**Comments on the Summary of the
Environmental Impact Statement**

**Tilt Cove Exploration Drilling Project
Proposed by Suncor Energy Inc.**

June 14, 2023

By the NunatuKavut Community Council

Figure 1: Diagram of movement of Atlantic salmon smolts.⁴

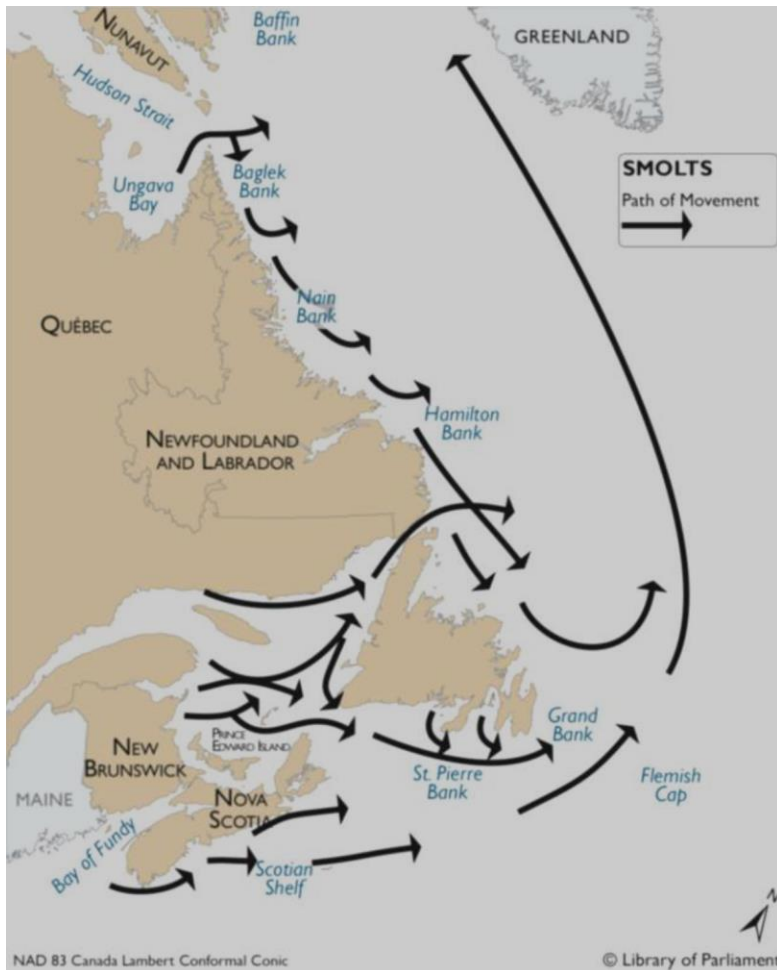
While some uncertainty exists, existing information about salmon migration patterns points to the fact that young salmon leaving natal rivers on the coast of southern Labrador, which is an important part of NunatuKavut traditional territory, often follow the flow of currents heading south, en route to feeding and overwintering grounds. In so doing, they pass rather directly through offshore development areas near the Flemish Pass, as shown in Figure 1, below. Information on smolt movements is referred to in both the BHP Canada EIS and West Flemish EIS, along with a map, reproduced below.

In light of the above, we strongly request that IAAC require the proponent to correct its analysis to factor in the Labrador population of Atlantic salmon, in section 6.2 and in all other places in the Summary EIS and full EIS where Atlantic salmon are mentioned.
